Access Compliance Report

Public Rights-of-Way

(Curb Ramps)

Intersection ID: 30341	Main Street: DULIN_CREEK_BV	Cross Street: GOLD_PAN_RD	Location: SW
ADA ID: F769DC82B724	Ramp Type: PerpDiag	Initial Pass/Fail: Fail	Overall Compliance: No
		Severity Score: 12.5

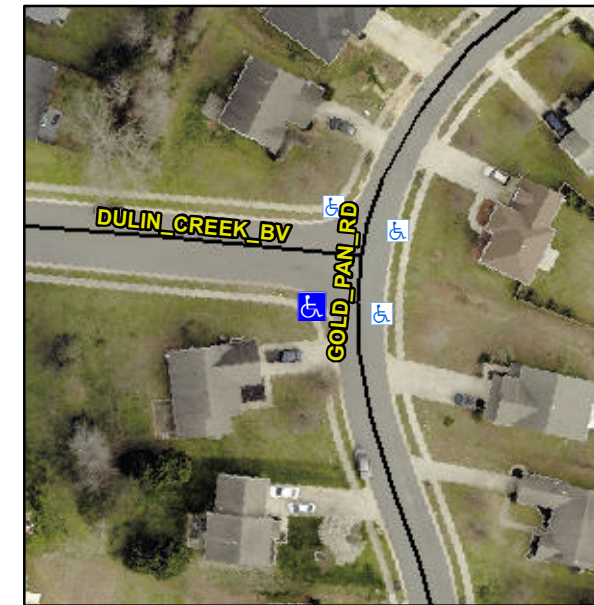
Not Found, R304.2.2

Compliance	Description	Data	Compliance	Description	Data
N/A	Ramp Length (in)	48.5	No	Ramp Slope (%)	9.3
Yes	Ramp Width (in)	52.5	Yes	Ramp XSlope (%)	1.3
N/A	Flare Type LT	N/A	N/A	Flare Type RT	N/A
N/A	Flare Slope LT (%)	N/A	N/A	Flare Slope RT (%)	N/A
N/A	Flare Traversable LT?	N/A	N/A	Flare Traversable RT?	N/A
N/A	Landing Length (in)	N/A	N/A	DWS Provided?	N/A
N/A	Landing Width (in)	N/A	N/A	DWS Contrast?	N/A
N/A	Landing Slope (%)	N/A	N/A	DWS Length (in)	N/A
N/A	Landing X Slope (%)	N/A	N/A	DWS Full Width?	N/A
N/A	Landing Curb? (Y/N)	N/A	N/A	DWS Offset (in)	N/A
N/A	Shared Landing?	N/A			
N/A	Gutter Ponding?	N/A	N/A	Gutter Slope (%)	N/A
N/A	Gutter Lip Ht (in)	N/A	N/A	Gutter X Slope (%)	N/A
N/A	Painted X Walk1?	No	N/A	Painted X Walk2?	No
	X Walk 1 Direction	To E		X Walk 2 Direction	To N
N/A	X Walk 1 Width (in)	N/A	N/A	X Walk 2 Width (in)	N/A
	X Walk 1 Slope (%)	2.7		X Walk 2 Slope (%)	2.2
	X Walk 1 X Slope (%)	1.4		X Walk 2 X Slope (%)	2.0

Remove & Replace Curb Ramp With Two New Directional Ramps or Equivalent.
